Urban Design Review Panel Report

New Campus Development for
The Ottawa Hospital
Phase 4: Main Hospital Project
Ottawa, Ontario

March 23, 2026
(Issued for SPC Resubmission)
Prepared by bbb Architects Ottawa Inc.

Figure 2.1-1: A0-221 PARKING LOTS ZONES 2A & ZONE 2B ZONE 4 ZONE 5B with dimensions at Main Drop-off Area

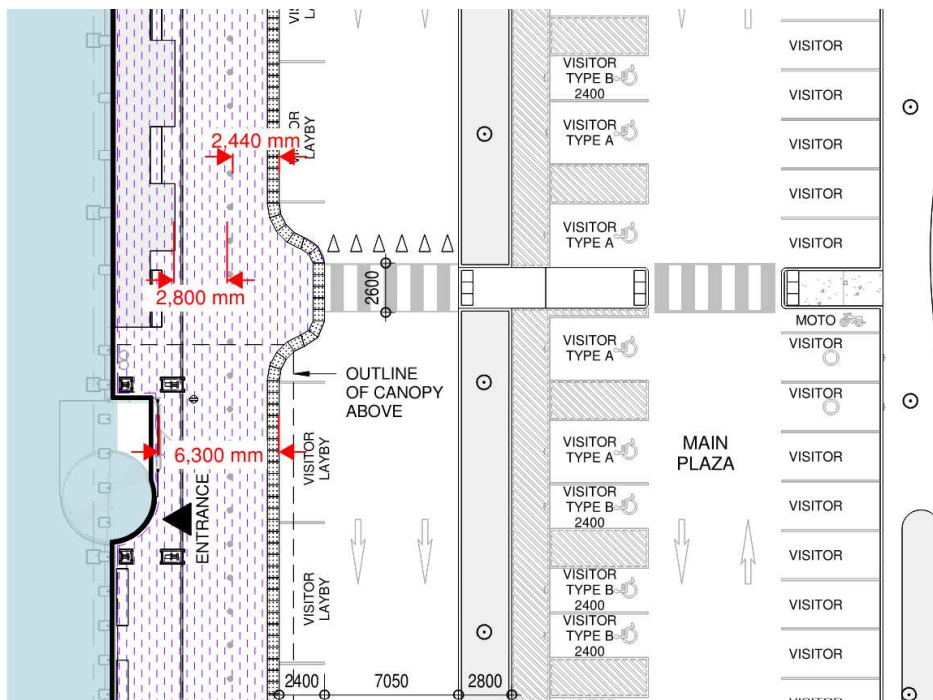
- The Panel expressed continued concern regarding the amount of space allocated to the main drop-off area.
 - The current pedestrian drop-off and pick-up zone, which is between 3.5 and 5 meters wide, remains on the narrower side given the level of activity expected in this area. The Panel recommends increasing the minimum width to 5 meters to better accommodate pedestrian movement and congregation.

The main drop-off area includes 6 layby parking spaces with adjacent access aisles that are a minimum of 2.44m wide. There is a sidewalk with a space of 2.8m from planter to bollards across the main pedestrian zone for a total width of 5.24m between parking spaces and planters. A distance of 6.3m is provided at the Main Entrance, refer to dimensions in Figure 2.1-1 below from A0-221.

Figure 3.1-1: Site analysis diagrams

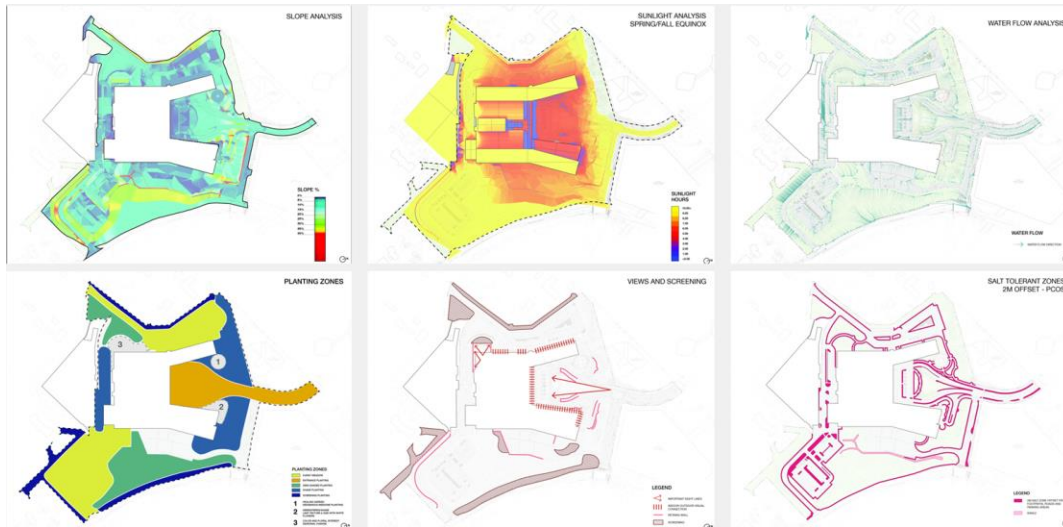
- The Panel recommends organizing the landscape into character areas to help rationalize the design moves and enhance the relationship between soft and hardscape elements, as well as improve connectivity throughout the site.

Site analysis was conducted to best understand the variety of environmental and visitor impacts. This site analysis informed the understory planting character of different zones across campus, including the entrance planting, sunny meadows, shaded woodland gardens and screening planting.

There are also four distinct gathering spaces on campus, each with distinct character defined by planting and topography, but with common materials and furnishings creating a cohesive campus identity. The Main Entry Plaza welcomes visitors to the hospital concourse, bringing a human scale to the plaza bordered by the towers and podium. The Overlook provides a space of respite for loved ones, or can act as an open, passive recreation space. Views to the Wooded Ridgeline and beyond to the City of Ottawa are enhanced by the framing grove of evergreen trees and the gentle slope of the landscape. The Dining Terrace offers space outside of the Pavilion for café seating and general gathering, set down from Road A providing some sense of intimacy and protection from the wind. The Healing Garden incorporates Indigenous design principles and medicinal plants, defined by a rustic dry-laid stone wall oriented to the cardinal direction points. Set within a birch forest, and further softened with native plantings as well as traditional medicinal plants, the space offers reflection and connection for visitors.

Figure 5.1-1: Comparison of the Tower End Façade from 35% Design Development (left) and Revised Façade to address recommendations (right)

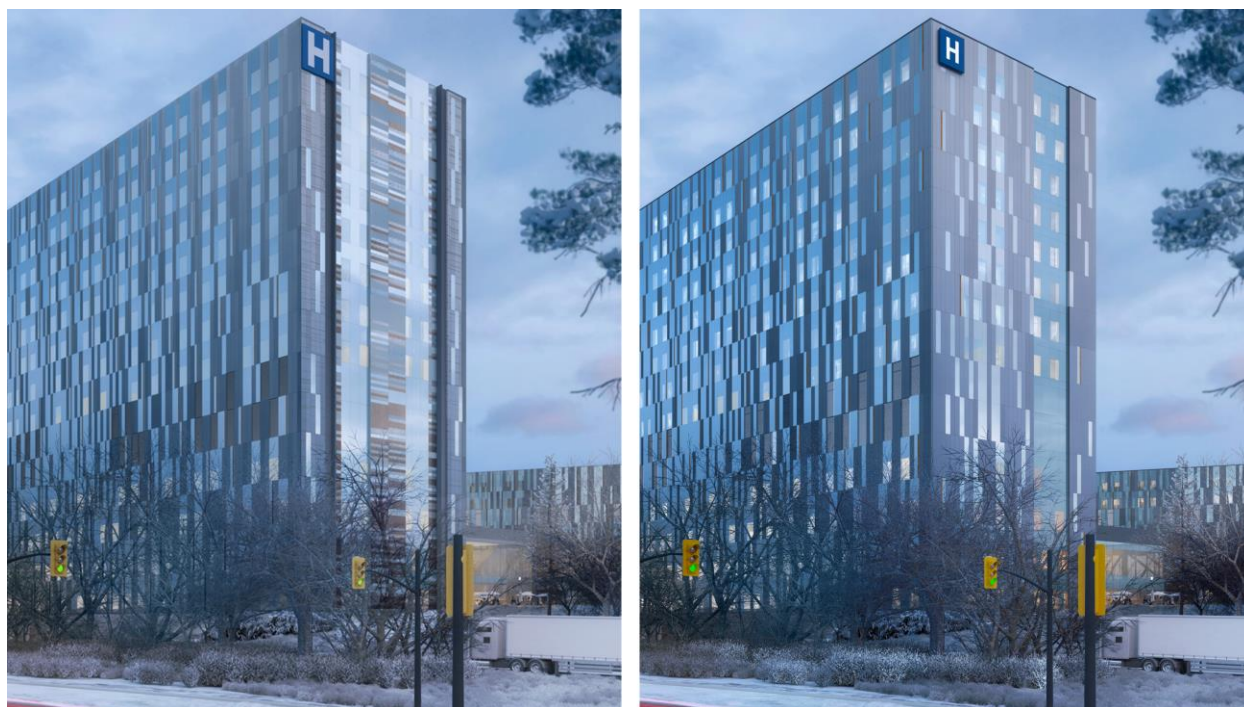
- The Panel recommends that the end façades of the patient towers maintain a simple and clear design strategy, ensuring consistency with the rest of the elevation treatments.

The overall architectural expression of the façades has been simplified by the refinement of the material selection as described in 2.2. For the tower ends, the design that was presented to UDRP included a horizontal expression of the Main Entrance framing façades in the centre of the towers. In response to the recommendation to simplify the façades, these tower ends were revised to instead wrap the Inpatient Room Façade expression around the corners. A simple glazed element extends vertically at the tower ends to relate to the expression of the tower hinges and express the circulation and corridors beyond.
